ENGINE - LP TURBINE ASSEMBLY - REPLACEMENT OF LP TURBINE ROTOR BOLTS - CATEGORY CODE 6  
- MOD.ENG-72-0015

V2500-ENG-72-0015

Location of LP Turbine Rotor Bolts  
Fig.1

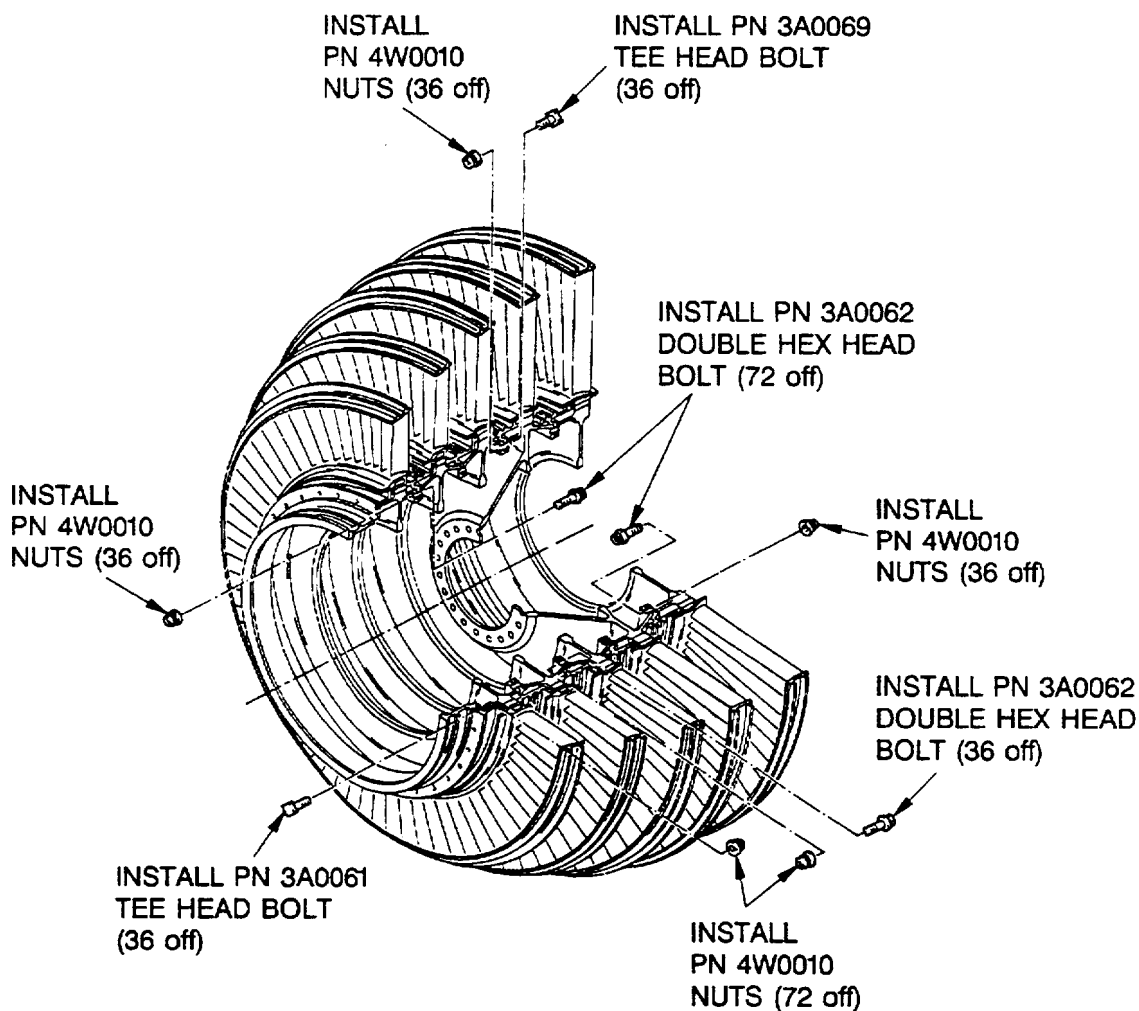
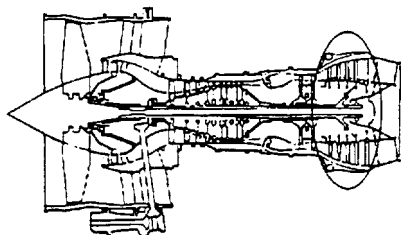
The Engine Serial Numbers listed above may have LP Turbine Rotor Bolts installed which do not fully comply with IAE specifications.

Tests and detailed inspection of LP Turbine Rotor Bolts have shown that some bolts were not delivered as specified.

- (1) Install new P/N 3A0062 Double Hex Head Bolts (108 off) by the instructions given in Reference (3), 72-50-10, Assembly 04, Assembly 06 and Assembly 10. Refer to Figure 1.
- (2) Install new P/N 3A0069 Tee Head Bolts (36 off) by the instructions given in Reference (3), 72-50-10, Assembly 08. Refer to Figure 1.
- (3) Install new P/N 3A0061 Tee Head Bolts (36 off) by the instructions given in Reference (3), 72-50-30, Assembly 01. Refer to Figure 1.
